Ref: 0417r02v02

**RE: 227 BUNGARRIBEE ROAD, BLACKTOWN (DA-21-00559)
KRISHATHI PTY LIMITED -V- BLACKTOWN CITY COUNCIL (LEC CASE NO. 2021 / 146822)
LETTER OF RESPONSE TO TRAFFIC CONTENTIONS**

We refer to recent correspondence concerning the abovementioned Court proceedings and the Statement of Facts and Contentions (SOFC) issued by Blacktown City Council (Council) dated 14/07/2021, relating to the deemed refusal of Development Application, DA-21-00559.

BUNGARRIBEE ROAD

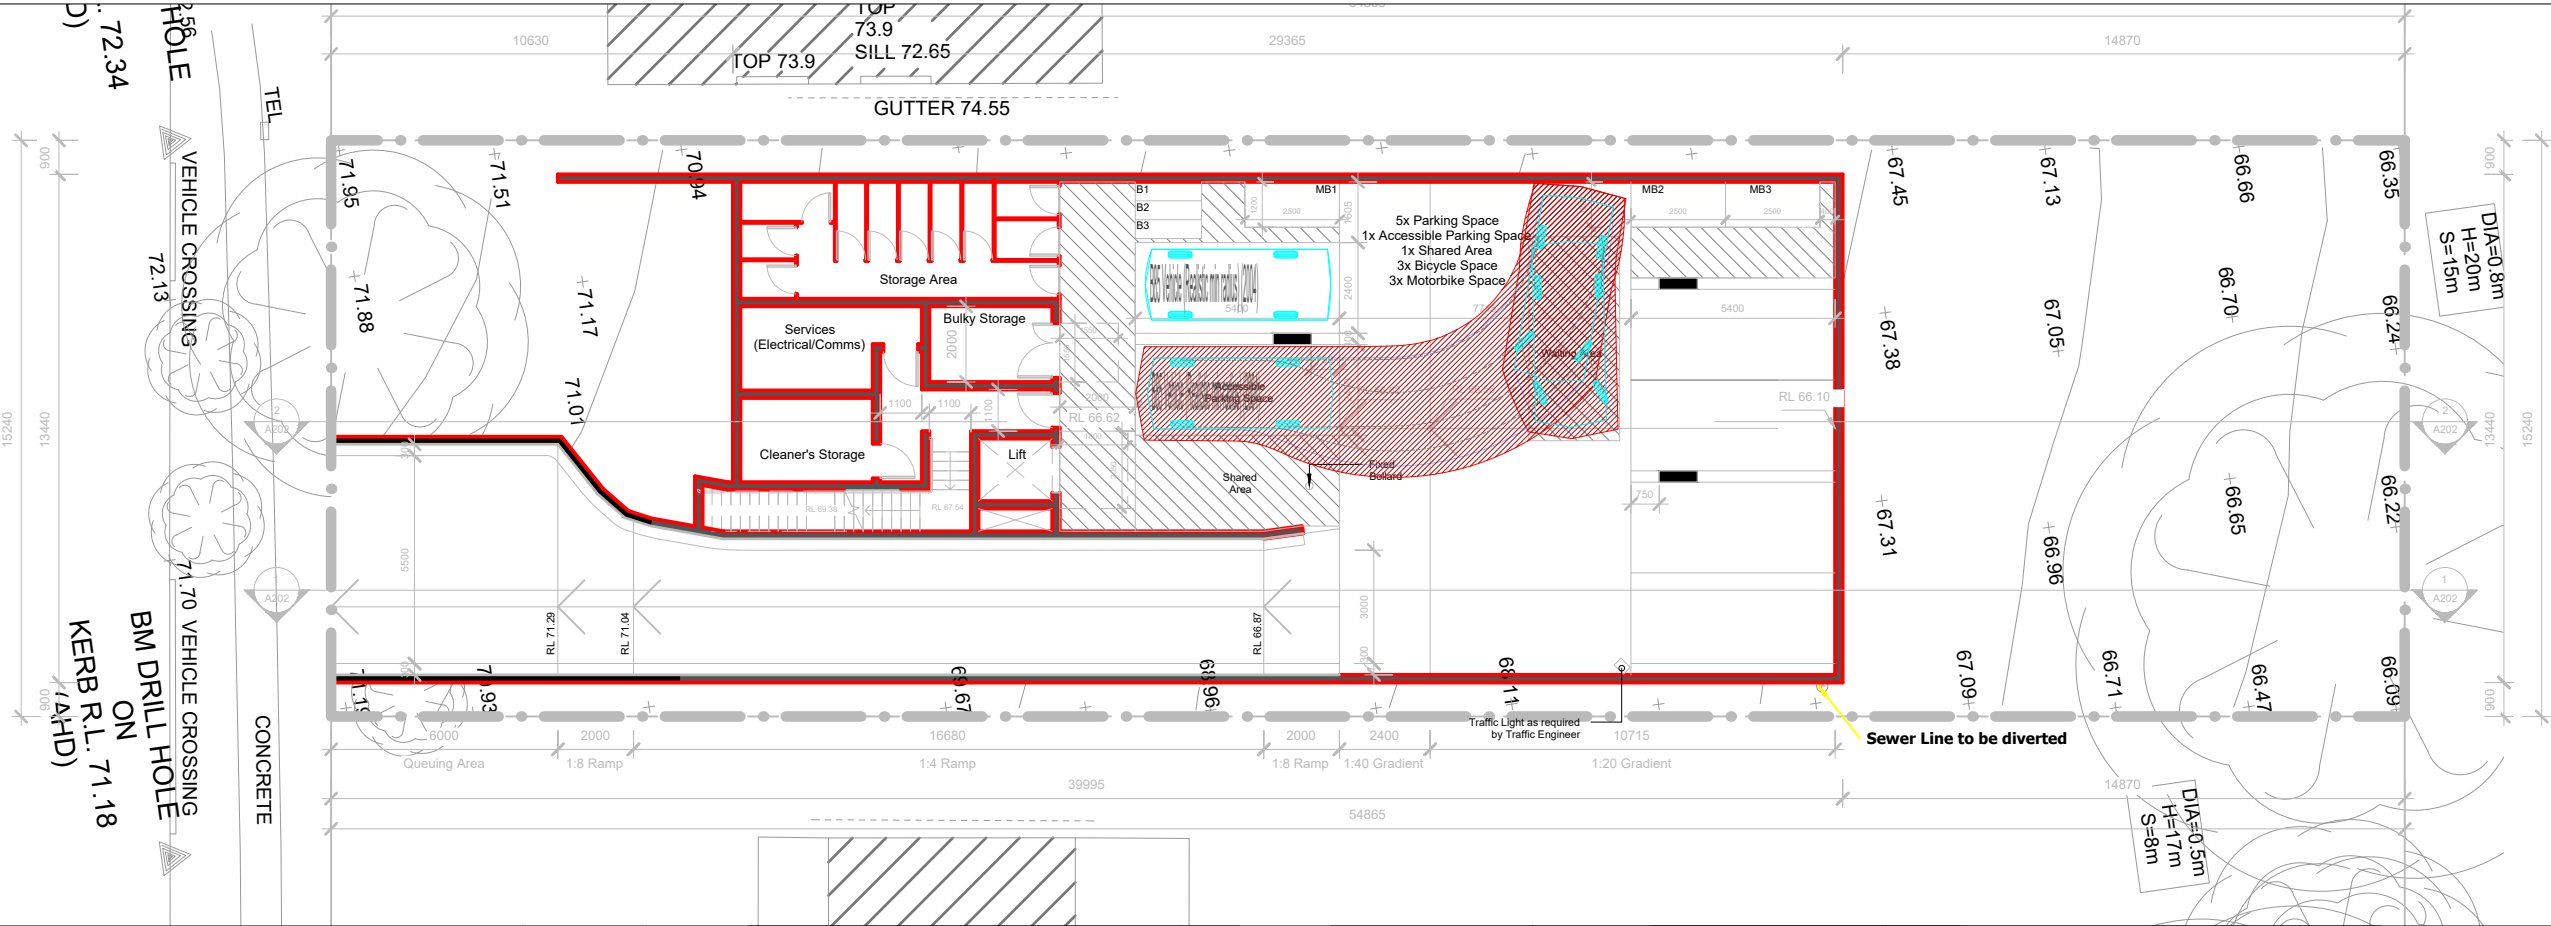
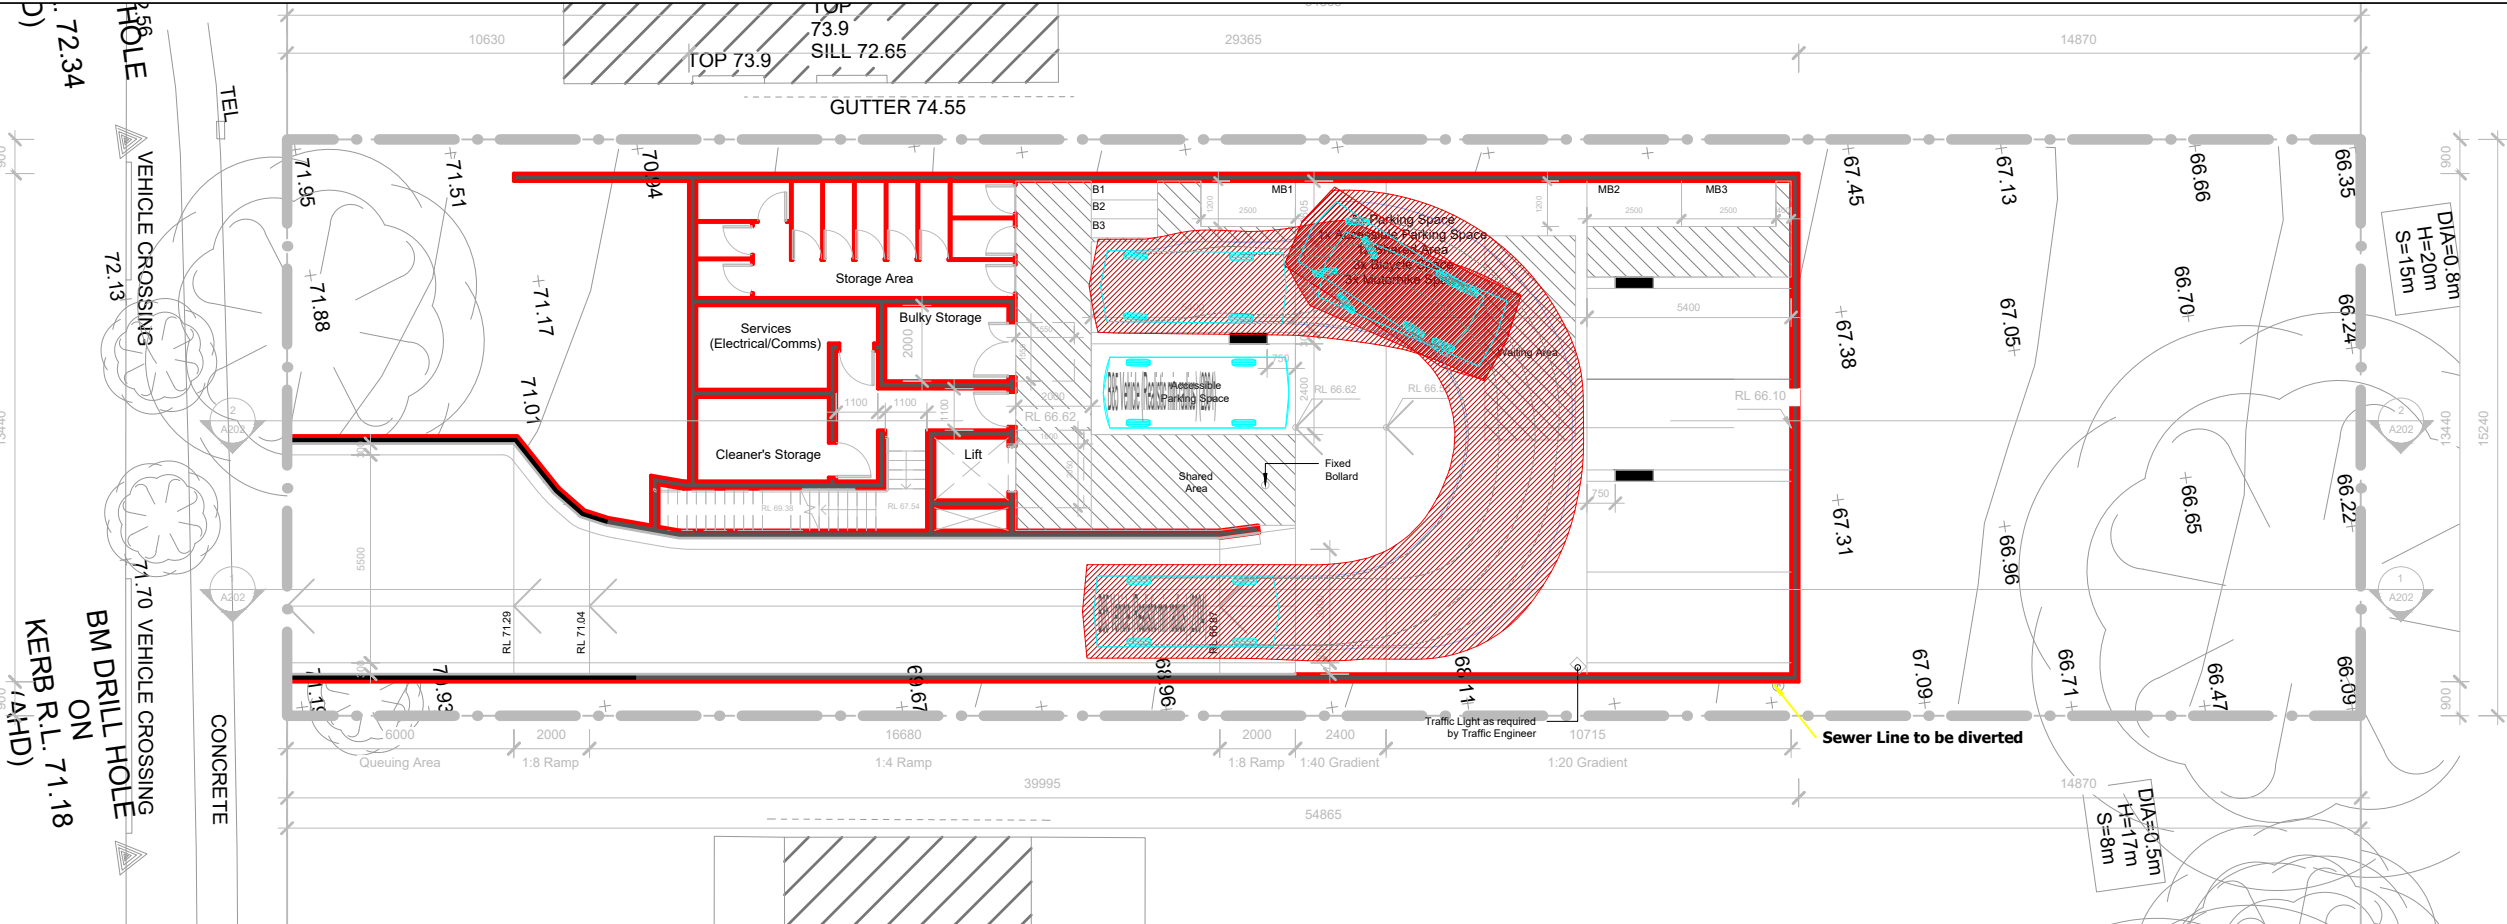
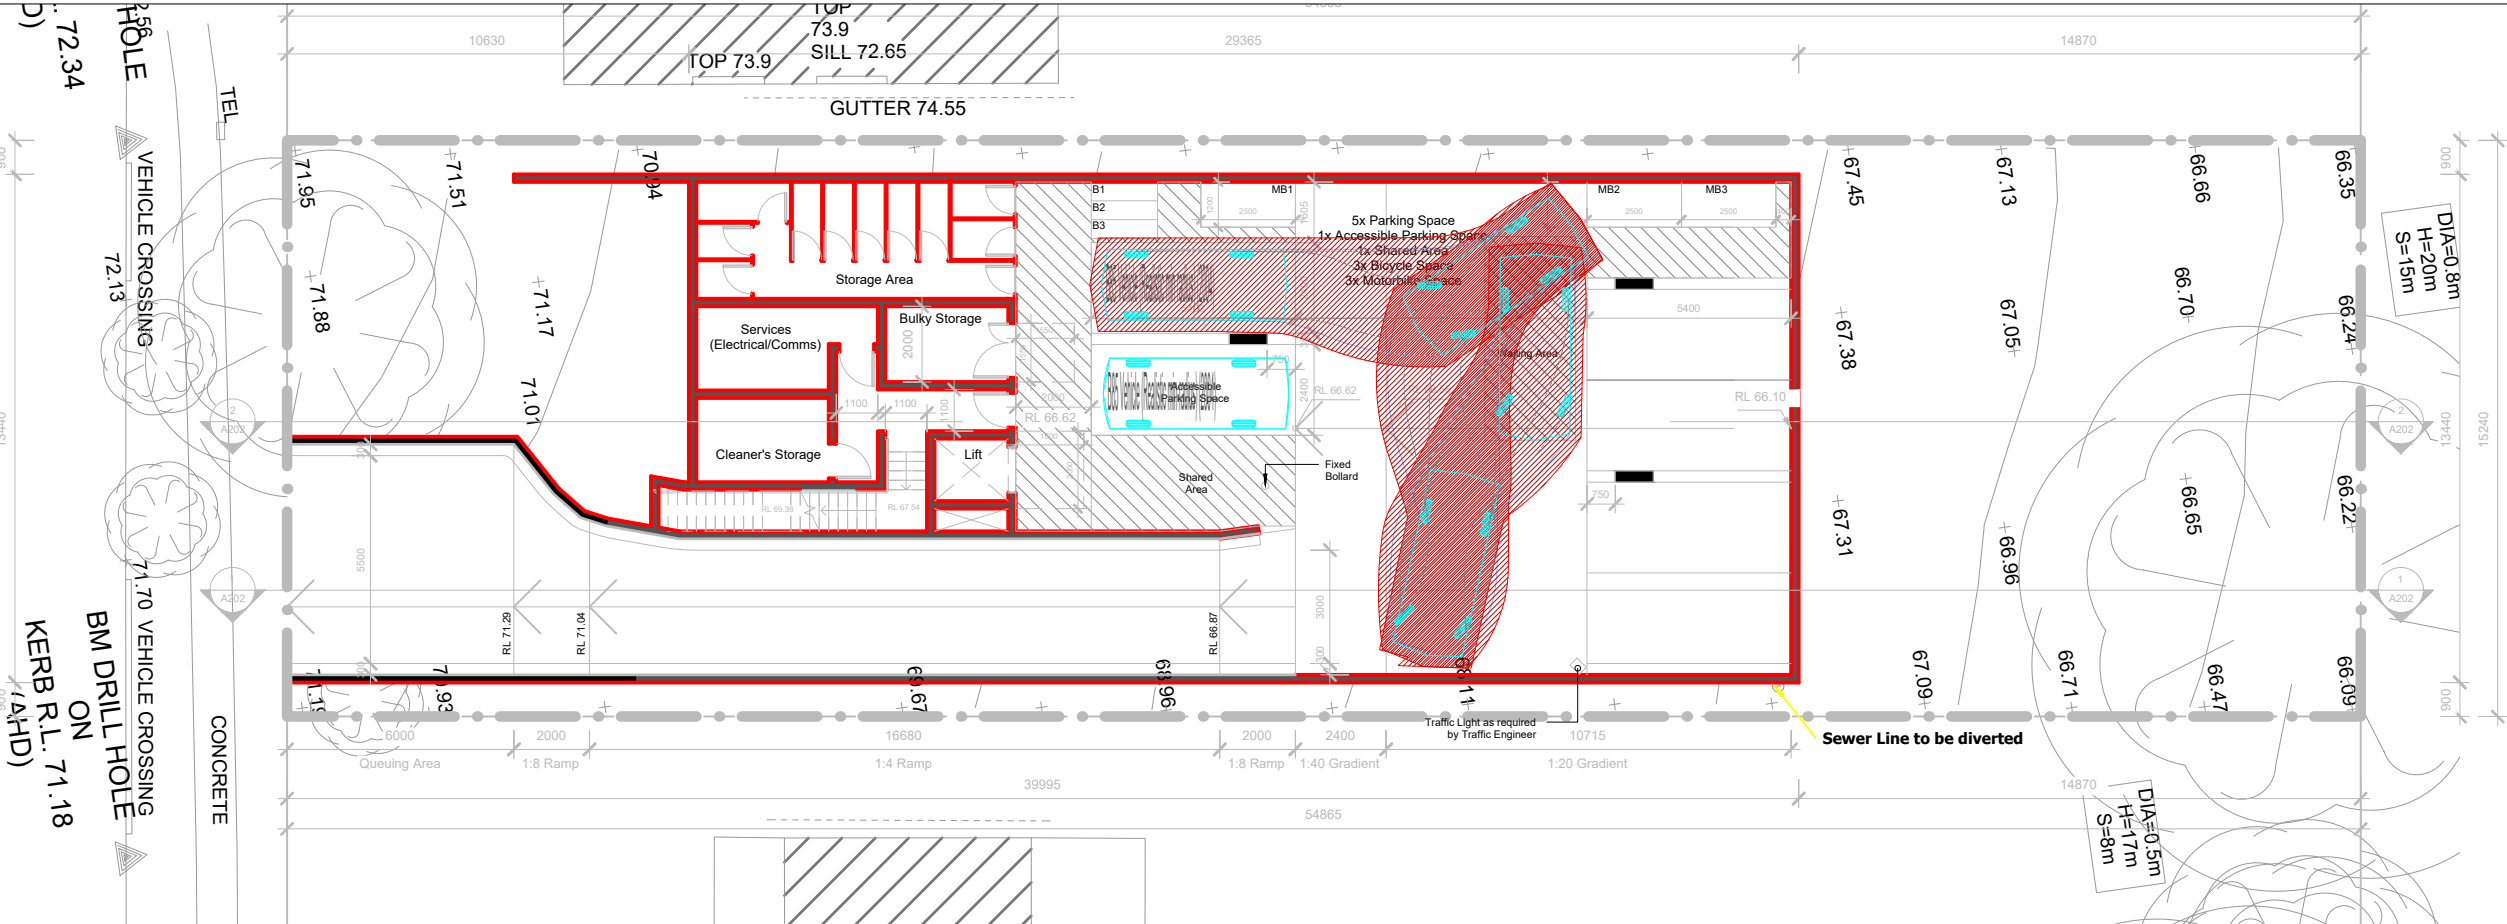
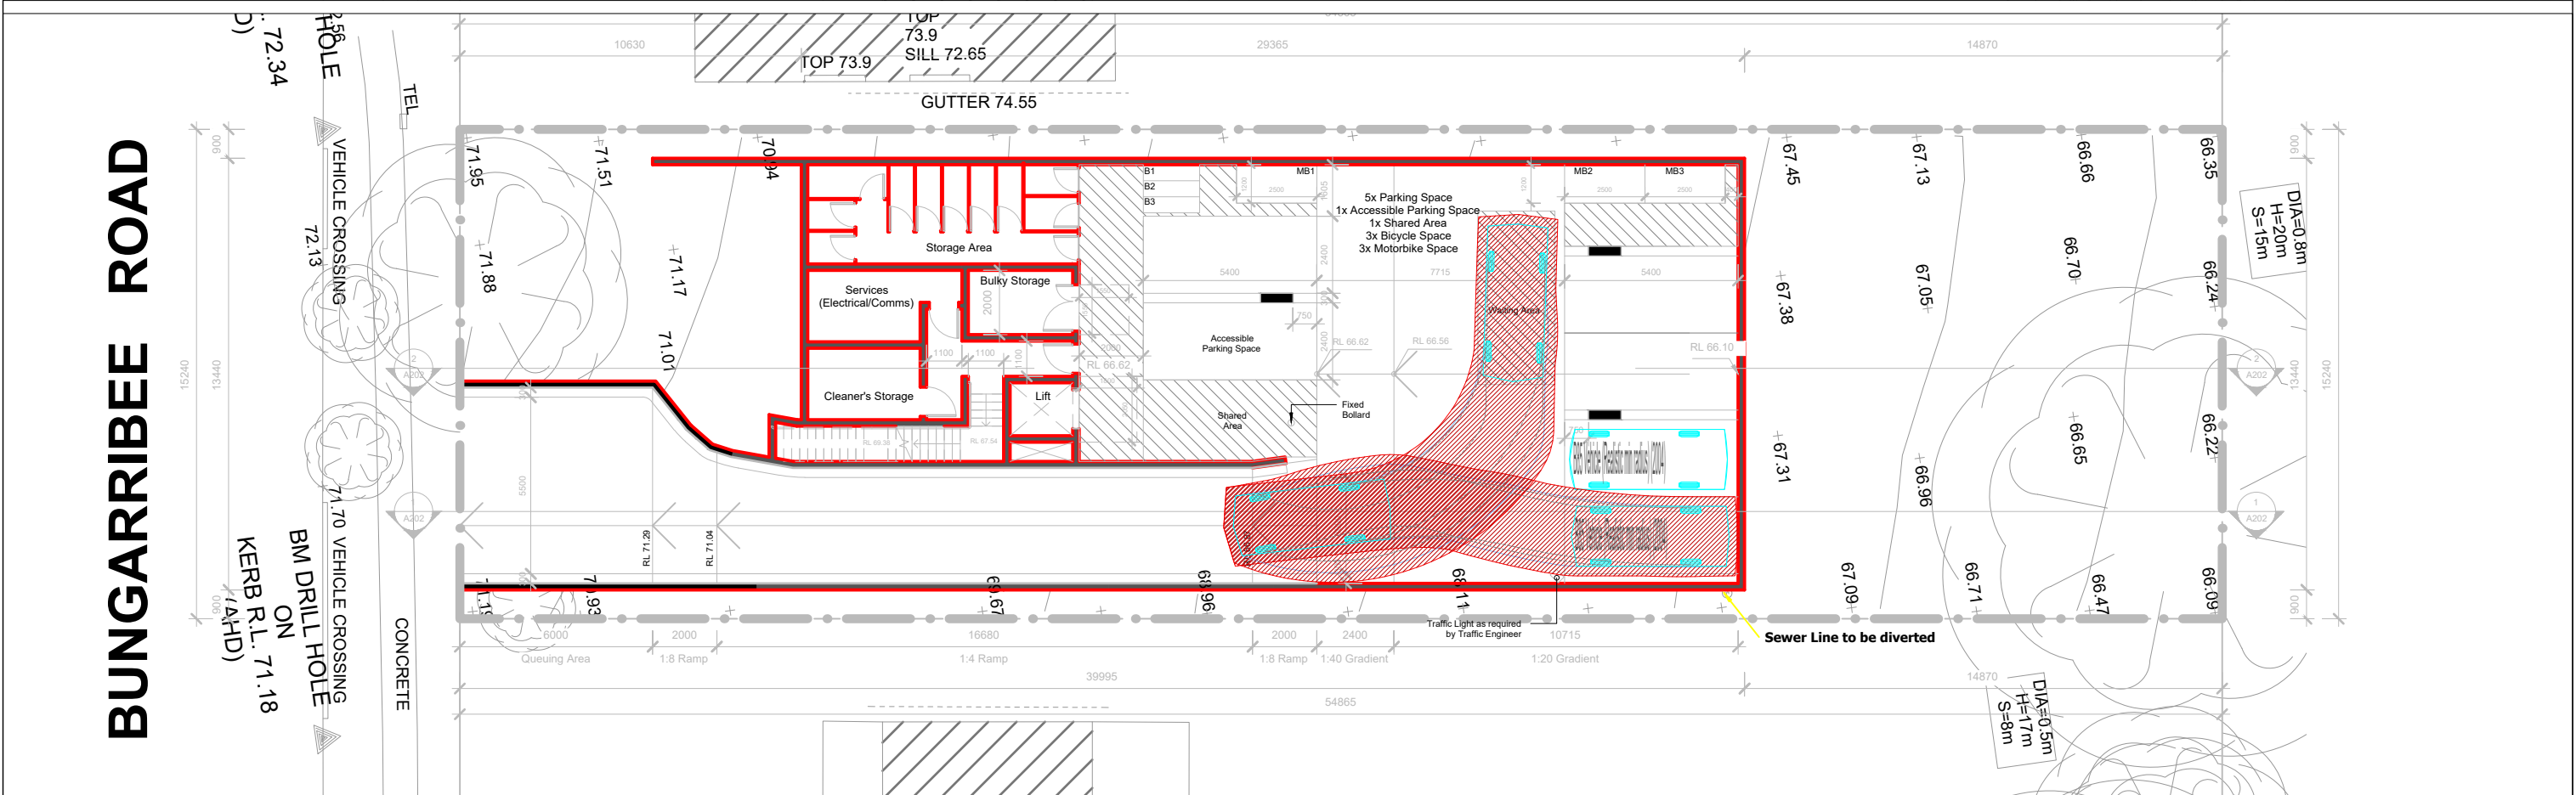
b) Insufficient turning circles have been provided in accordance with Section 2.5.2 of AS2890.1 for passing at the site driveway and within the basement. Turning paths are to be provided for the B99 design vehicle turning left into the site driveway from the public road and passing a B85 design vehicle exiting the site in addition to swept paths for the B99 design vehicle within areas designed for use by one vehicle at a time.

d) Turning circles in the basement are not practical or workable for cars. The results show the required 0.3m vehicle clearance overlapping with high obstructions (walls, columns, motorcycle spaces, kerbs and car parking spaces) which is contrary to the requirements of AS2890.1. It appears 'turn on spot' has been used for swept paths (basement and along the driveway) which is a design flaw not representing realistic vehicle manoeuvres. The dwg files for the swept paths are to be provided.

Updated swept path analysis has been undertaken of the vehicle access with the results provided as **Attachment 2**. The results demonstrate satisfactory turn movements for a:

- B99 Design Vehicle turning left-in and left-out of the access driveway from the public road and passing a B85 Design Vehicle.
- B99 Design Vehicle entering the basement car park and passing a B85 Design Vehicle situated within the waiting bay.
- B99 Design Vehicle exiting the basement car park.
- B85 Design Vehicle entering / exiting all car spaces.

The results demonstrate satisfactory operation of the car park and compliance with Appendix B of AS 2890.1.

As per our respond to Contention 6(b), updated swept path analysis has been undertaken of the basement, including for entry / exit to all car spaces with the results provided in **Attachment 2**.

The 'turn from stop' function has only been used where a vehicle has changed from a forward-movement to a reverse-movement or from a reverse-movement to a forward-movement as is standard practice in the traffic engineering profession. The updated swept path results also show that 0.3m clearances are now clear of all vehicle obstructions including walls, columns, motorcycle spaces, kerbs and car parking spaces.
